SHEET		1		OF		1	
MESA TOPS AT RIDGEGATE		ENTRANCE ROAD ALT A — W/O WALLS					
JOB NO.		15950.12

MESA TOPS AT RIDGEGATE
ENTRANCE ROAD ALT B
WI WALLS

PRELIMINARY ROAD REDESIGN
ALTERNATIVE 1
MESA TOPS – CABELA DRIVE
1595018
10/28/2024
SHEET 1 OF 2

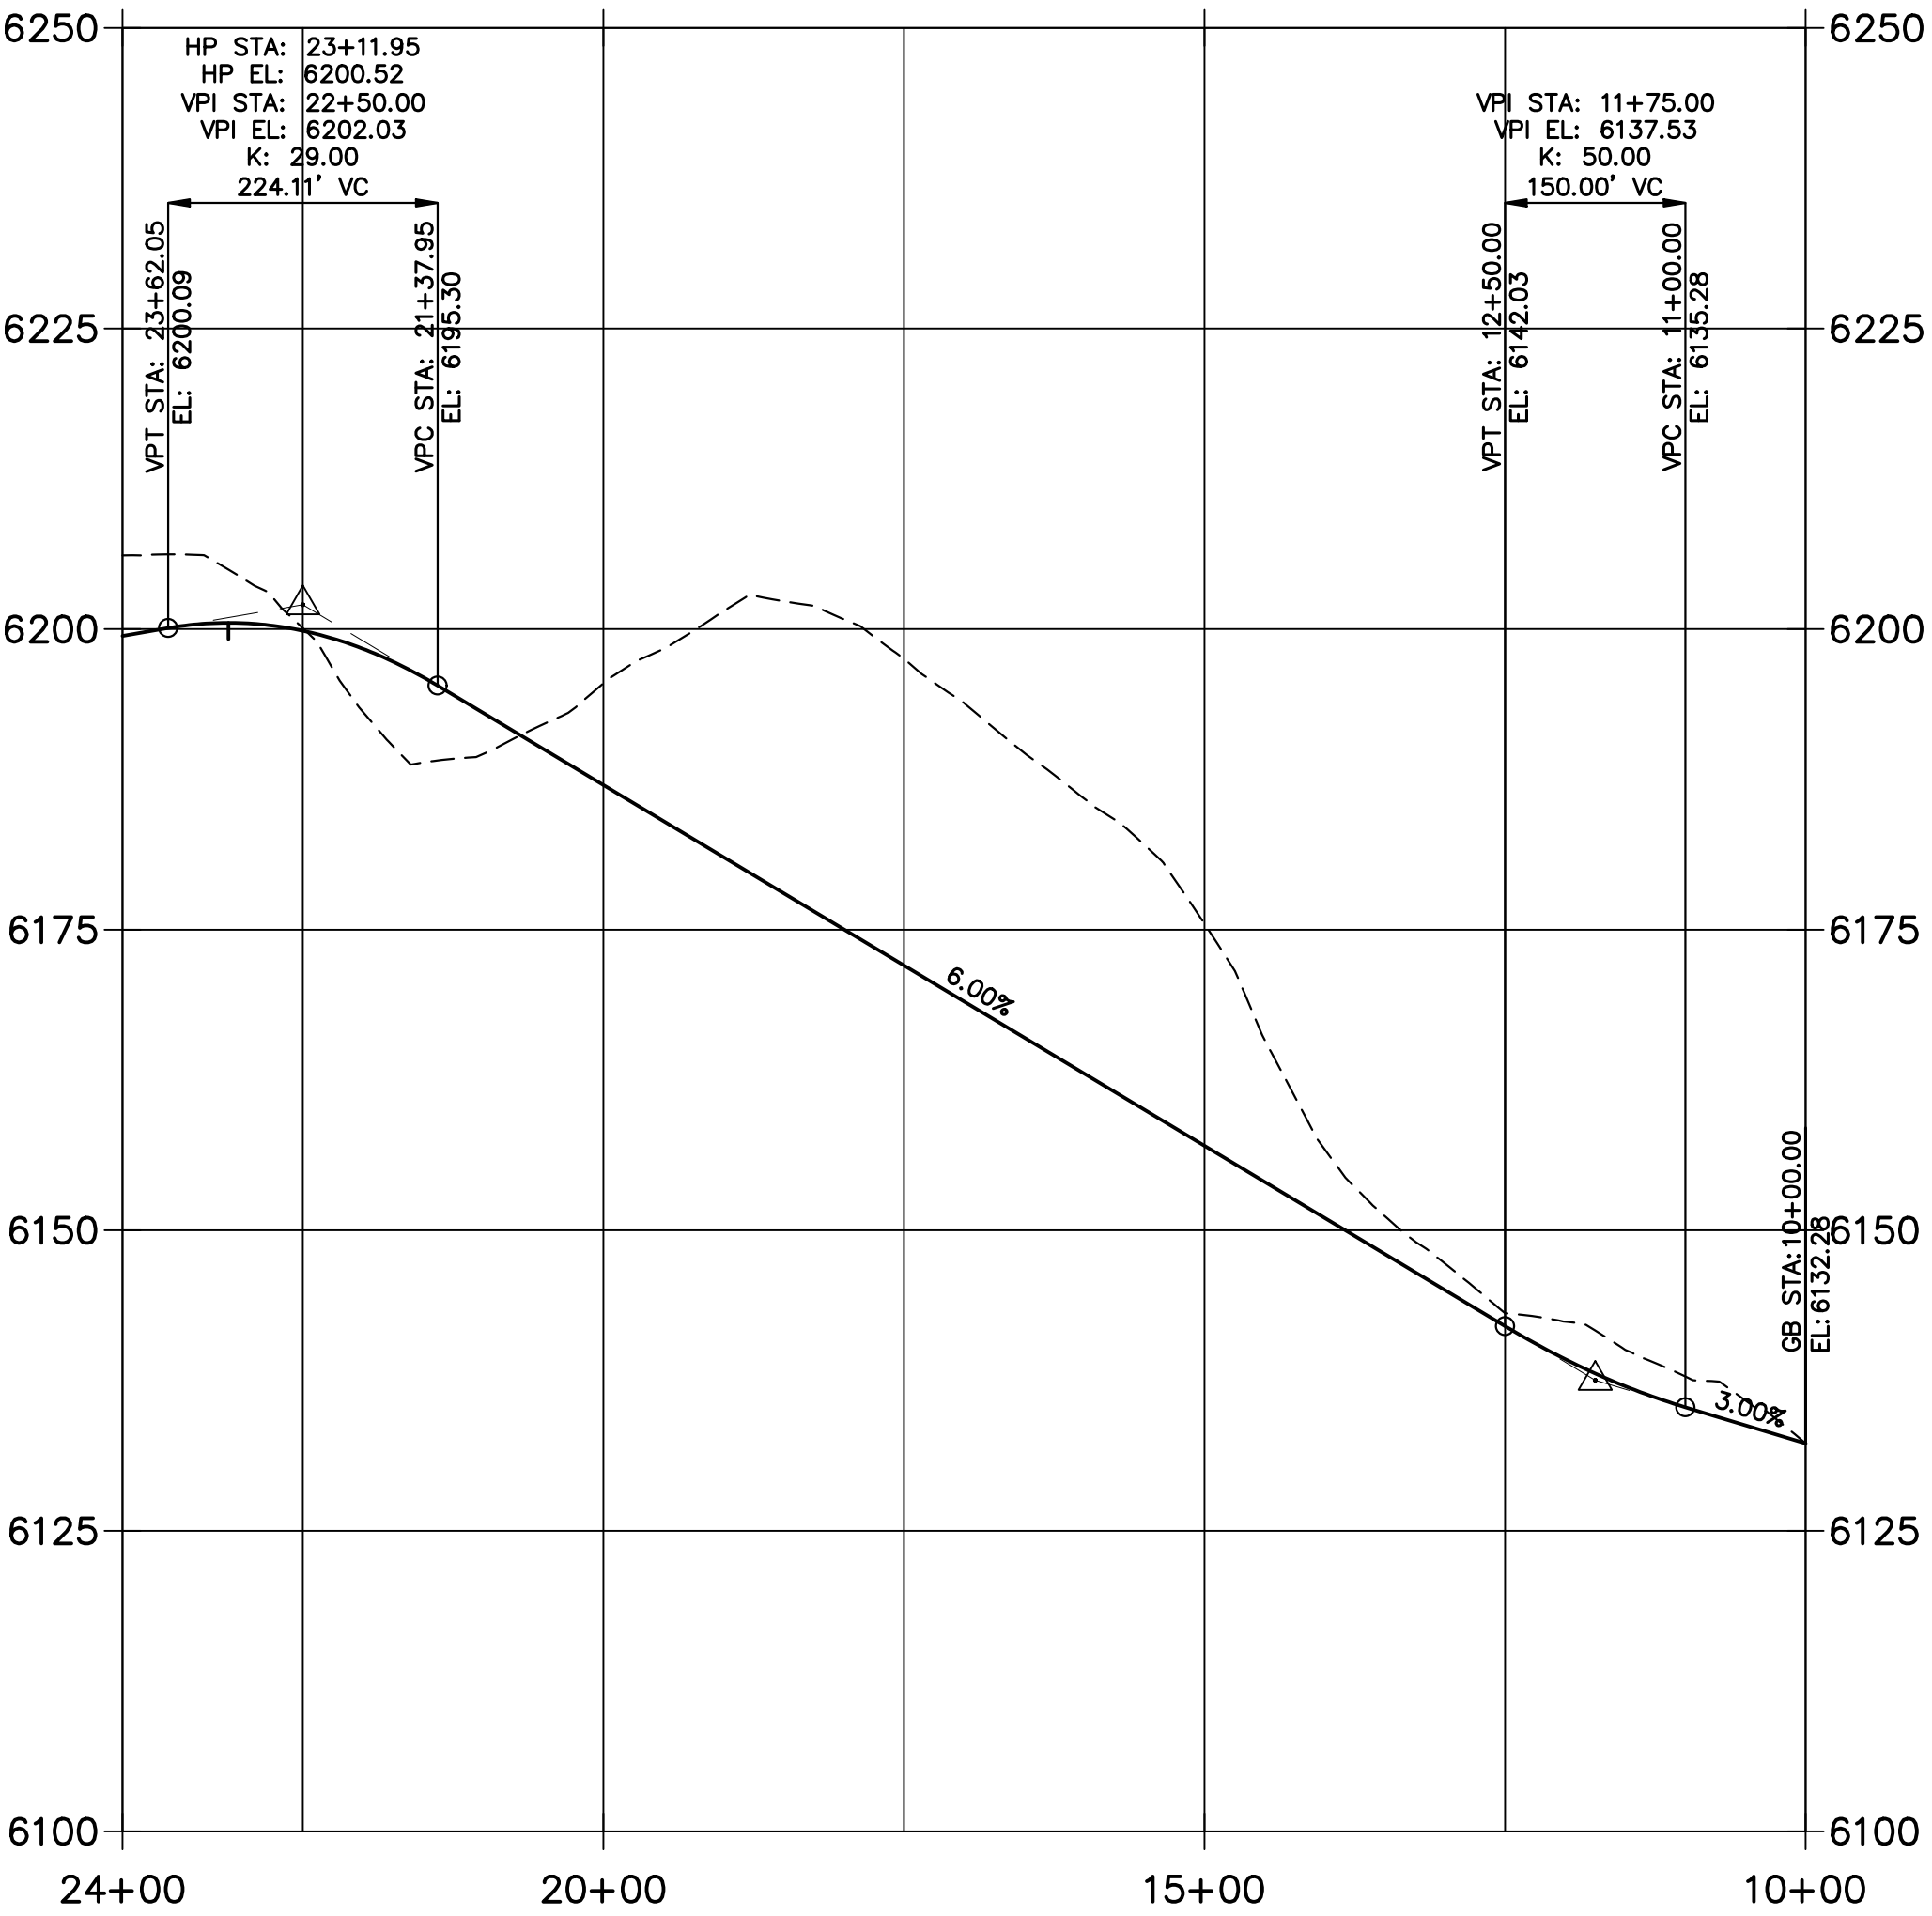
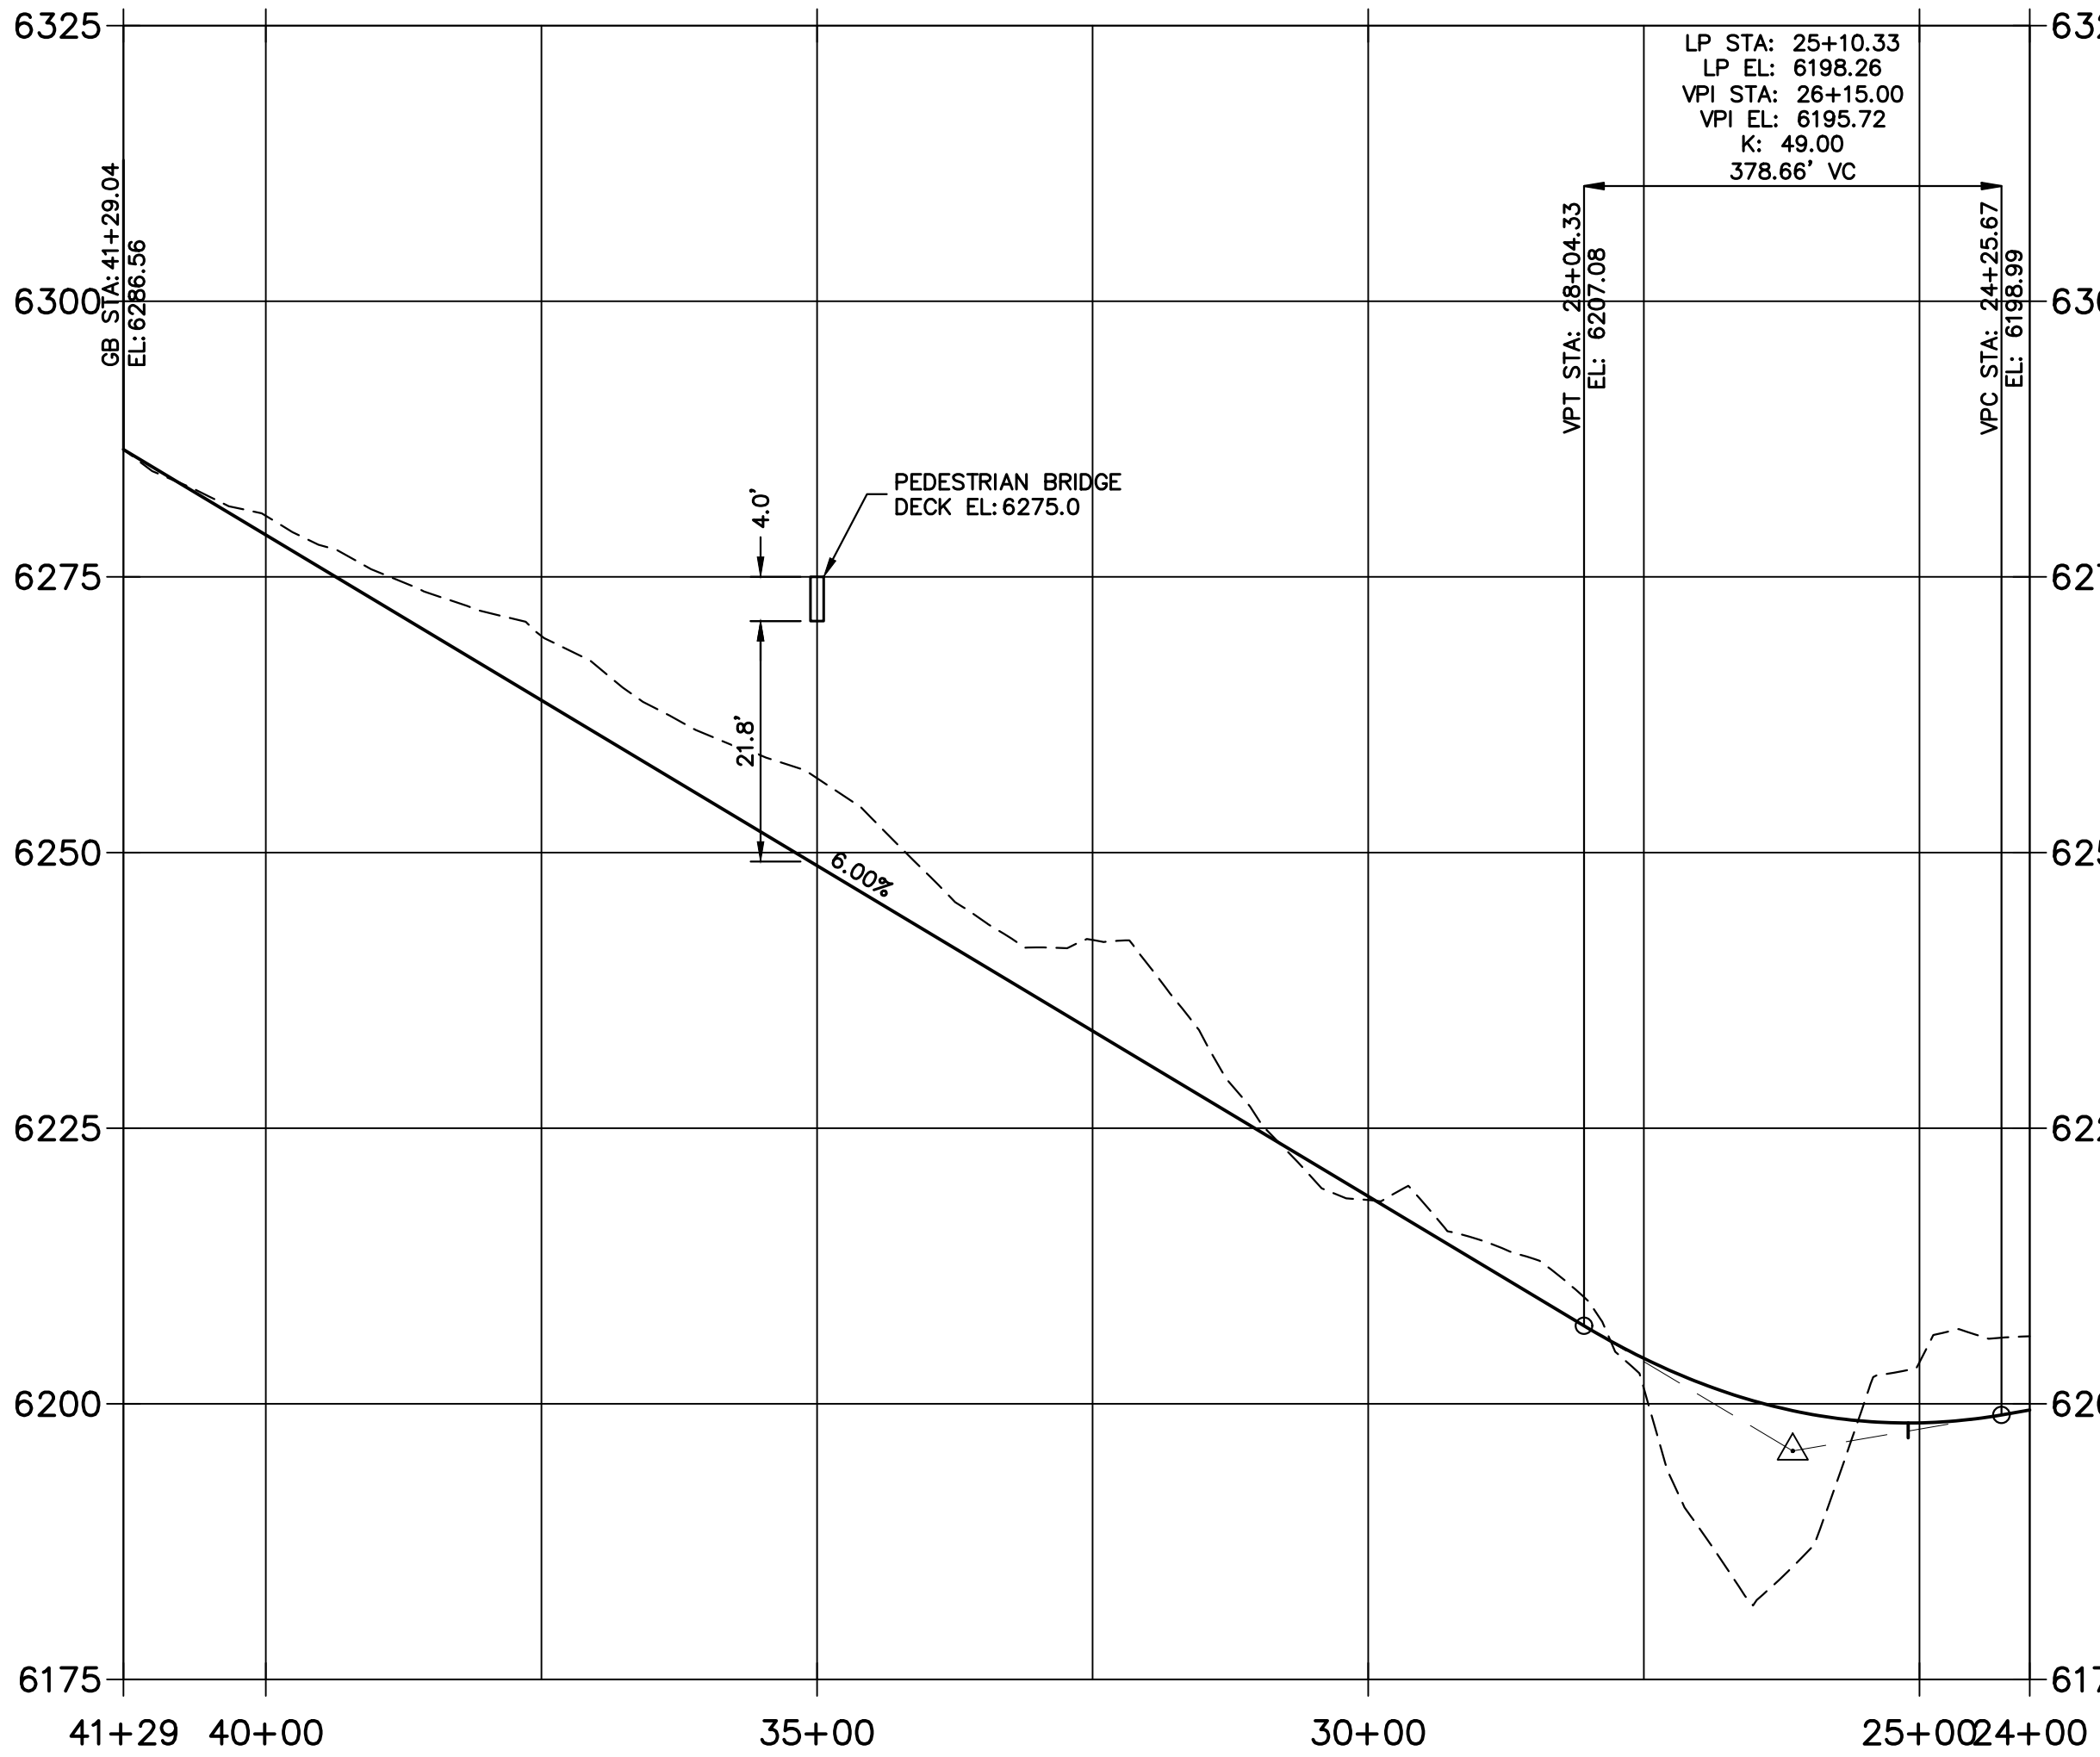
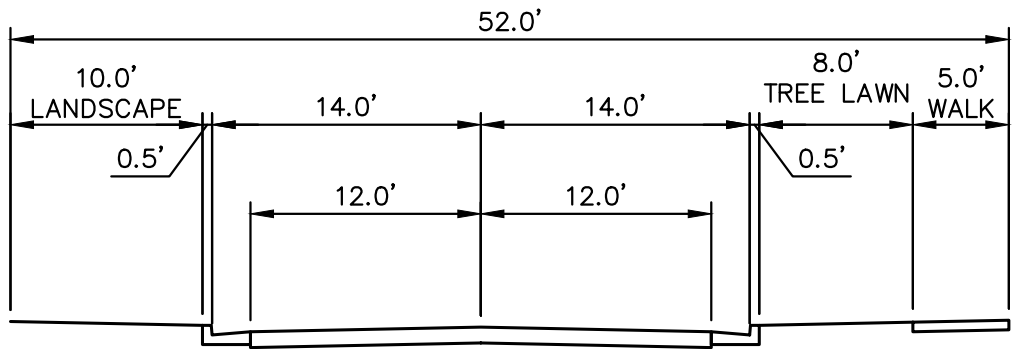
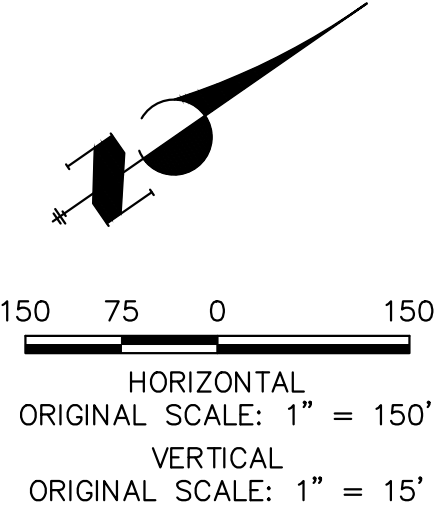
Option not selected -

- Option included a significant amount of retaining walls. A combination of walls and slopes was ultimately chosen.
